TOWNSHIP OF WEST ORANGE

FROM: Paul Grygiel, AICP, PP, Township Planning Director

DATE: March 8, 2021

RE: **ZB-21-05/Tamay**
Block: 125.02; Lot: 100; Zone: R-T
60 Cherry Street
Seeking "c" variances to construct an addition to a single-family residence

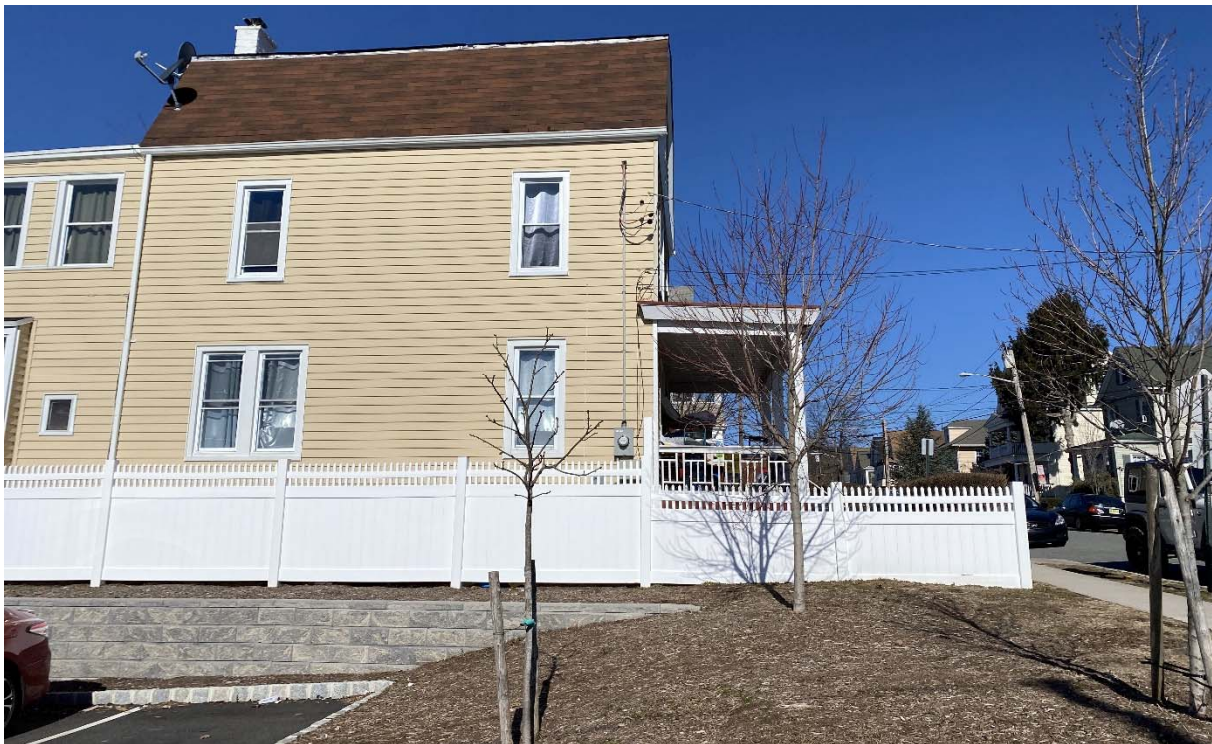
The applicant is proposing to enclose part of an existing porch and construct an addition to the front of an existing single-family dwelling. The height of the proposed addition is approximately 22 feet, 8 ¼ inches. The area of the enclosed porch and a new vestibule on the first floor will be 172 square feet, and the second floor addition will include 146 square feet. An enclosed balcony will be provided on the second floor above the enclosed first floor porch. The front stoop will be expanded slightly, resulting in an increase in the existing nonconforming lot coverage.

No other changes appear to be proposed to the dwelling or property. The applicant should confirm that is the case.
